RE: 55 Rogers Street

I reviewed the drawings, evaluated the site context and prepared a review letter on this project in April 2017. My comments and recommendations on this revised design are as follows:

CURRENT
REAR ELEVATION

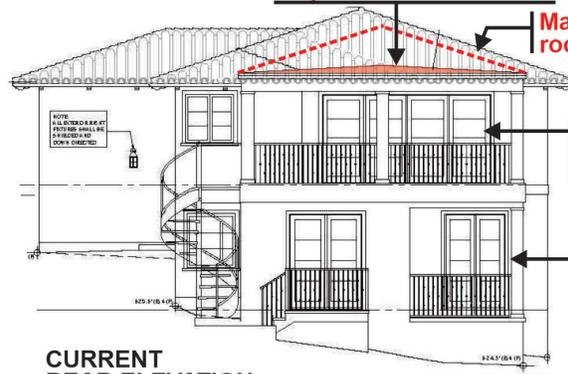
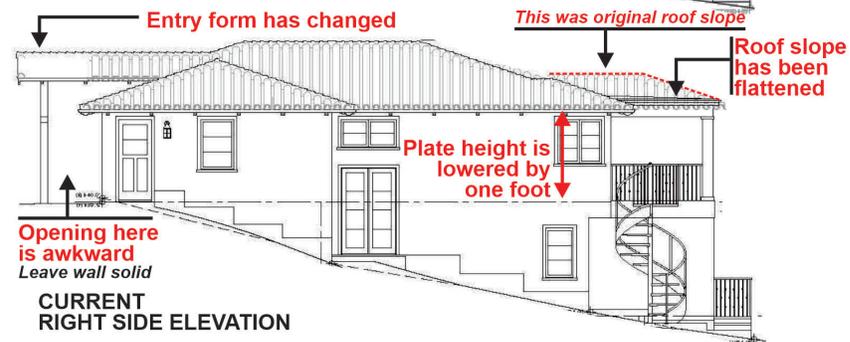
Appears that porch roof slope has been flattened

Match main roof slope

Covered porch is wider

Covered porch is added

3. The covered porch off of the Great Room on the main floor level is wider.

4. A covered porch off of Bedroom 2 on the lower floor level has been added.

6. The roof slope over the rear main floor covered porch has been severely flattened from the original design. The change is not readily apparent because the previously proposed roof is still shown on the two side elevations.

Comments: The change is not consistent with the architectural style and Residential Design Guideline 3.5.1.

Recommendations: Modify the porch roof slope to match those of the main roof.

CURRENT
RIGHT SIDE ELEVATION

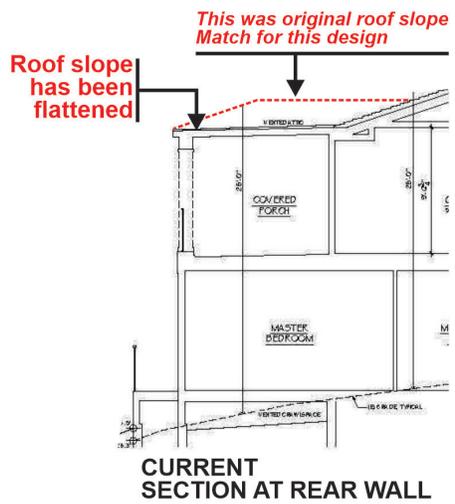
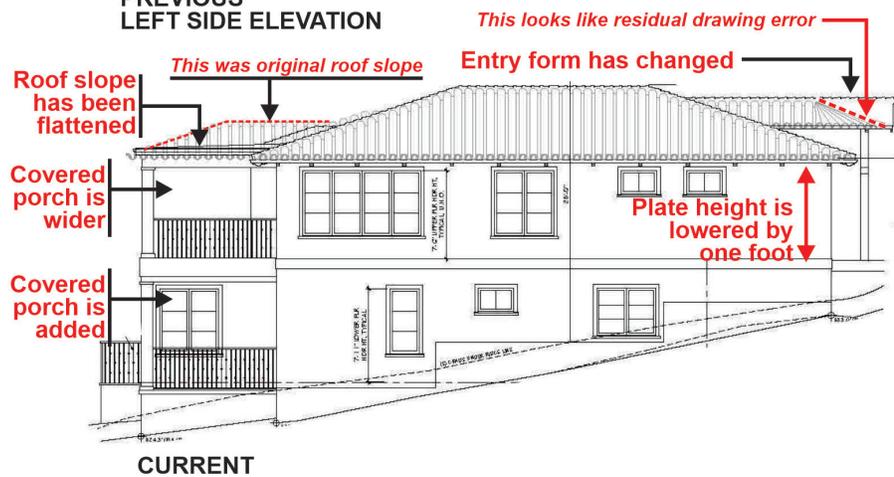
Entry form has changed

This was original roof slope

Roof slope has been flattened

Plate height is lowered by one foot

Opening here is awkward
Leave wall solid

1. The entry form has been changed.

Comments: The form change is consistent with the architectural style, but the open side wall adjacent to the garage is not. The height of the roof, however, is too high.

5. The plate height on the main floor has been lowered by one foot.

Recommendations: Maintain solid walls on the sides of the projecting entry form, and lower the roof height.
